## **1EWo3 - Enabling Works Central**

# **AWHi – Fieldwork Change Control Form A (Spec A) for Mitigation by Design at Colne Valley Wetland, Colne Valley Viaduct, Hillingdon (C10049, FCCFAo24**

Document no.: 1EW03-FUS-EV-FRM-CS01\_CL01-000031

## Appendix 1: Sketch of the Align Main Works Landscaping design

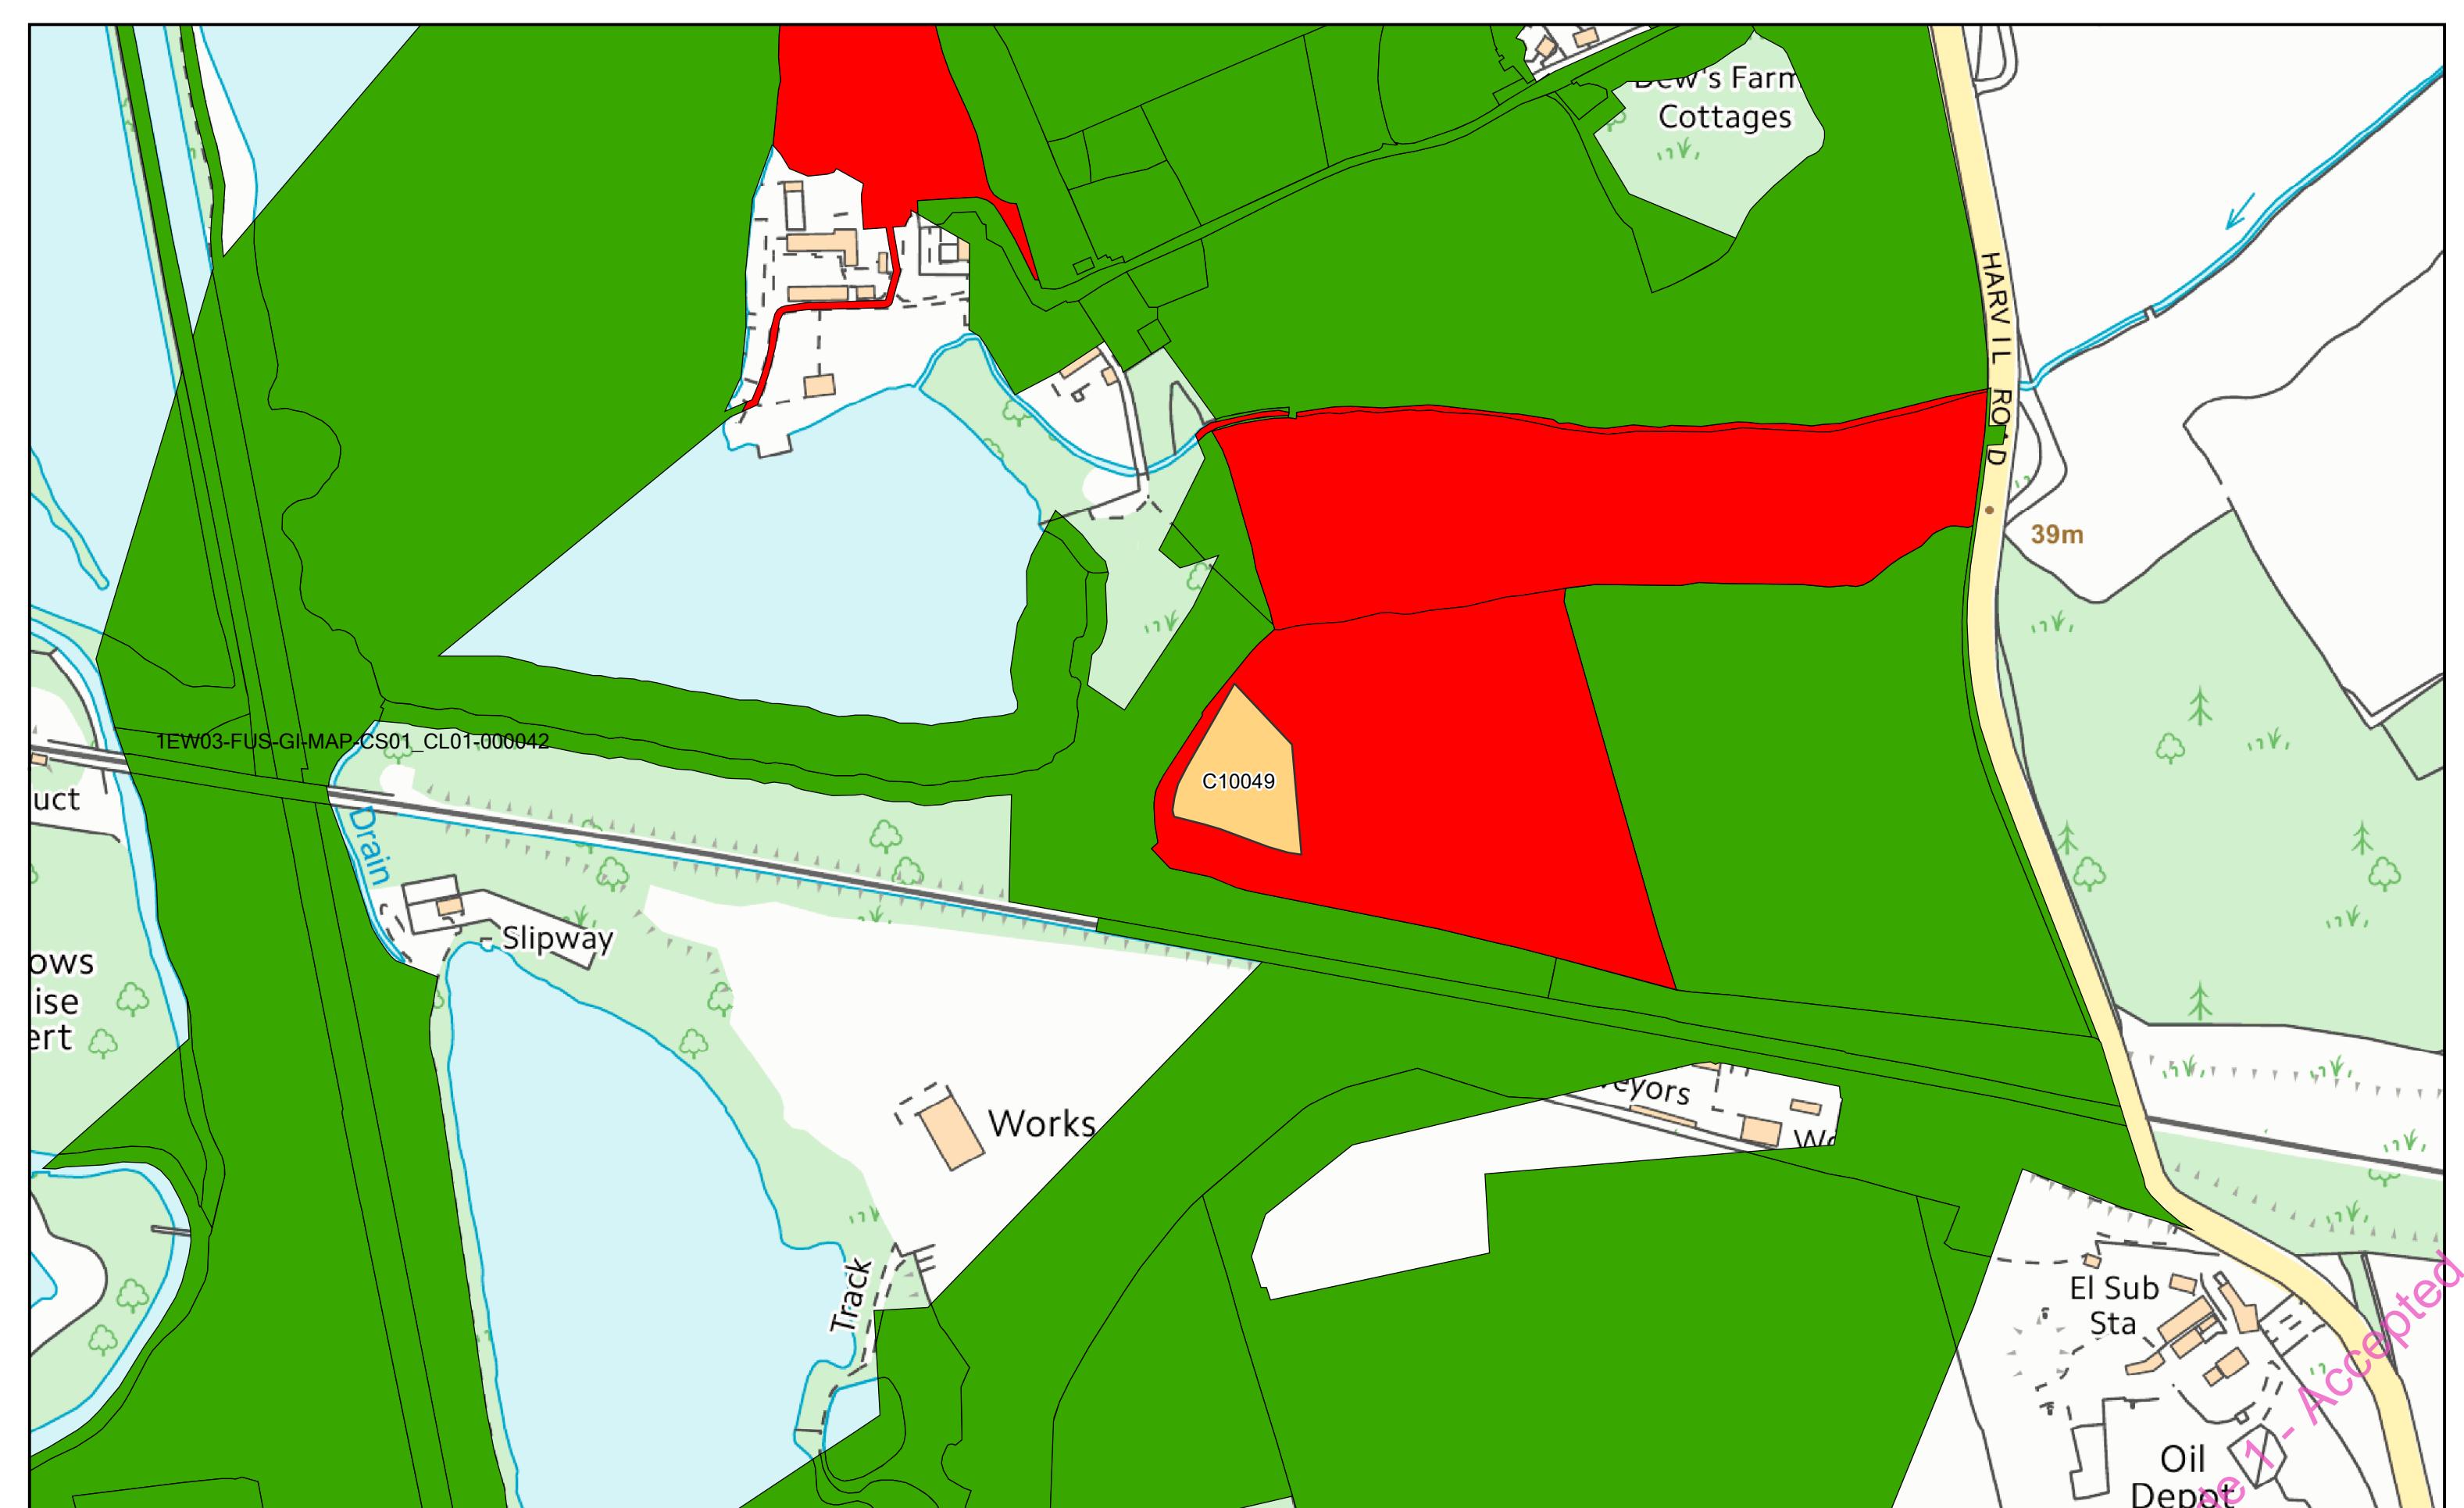
AWH – Fieldwork Change Control Form A (Spec A) for Preservation in Situ, at Colne Valley Wetland, Colne Valley Viaduct, Hillingdon (C10049), FCCFA024			Appendix 2	<p>It would be useful to mark the precise area covered by the FCCF on the Align landscape design.</p>	13/07/2021	Cannot be achieved - Align drawing is a sketch/representation and not to scale so an accurate overlay cannot be shown
